AL FATAH RIVER CROSSING
TIE-INS
AL FATAH, IRAQ

SIGIR PA-05-012
MARCH 15, 2006

Al Fatah River Crossing Tie-Ins at Al Fatah, Iraq

Figure 1 is the pipeline schematic showing general layout of the manifolds and pipelines.

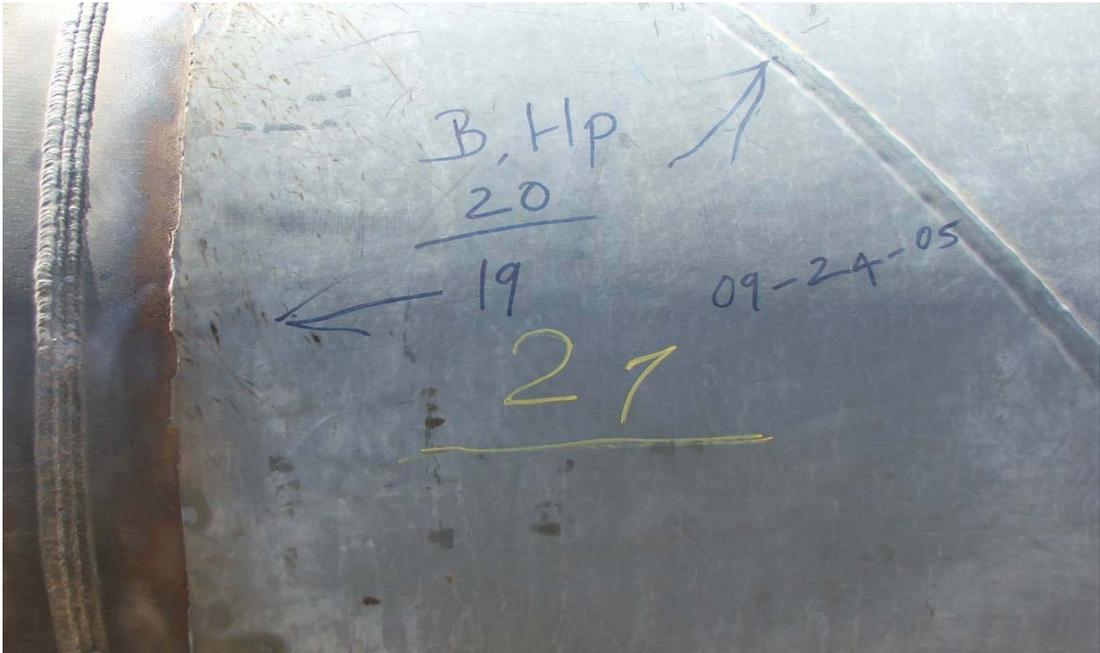
However, operational effectiveness of the project would be improved by connecting the 40-inch ITP at the Kirkuk manifold to the terminus of the new 40-inch pipeline coming from the Kirkuk oil fields, which were not included in the original SOW. Connecting the manifold to the new 40-inch Kirkuk pipeline would be a cost efficient approach to substantially increase oil revenue due to enhanced manifold flexibility and increased crude oil flow capacity. As the result of the engineering team's assessment work, the SIGIR recommended a modification to the project design that would, at minimal cost, substantially increase the overall carrying capacity of the crude oil pipeline system.

A plan to implement the recommendation was initiated by the USACE during the timeframe of the assessment. Specifically, the USACE advised that piping material, equipment, and skilled labor were on the site and that the modification could be completed with negligible impact on the project schedule and budget. It is estimated that the change could increase pipeline carrying capacity by as much as 50 percent, with a corresponding increase in revenue to the Iraqi government.
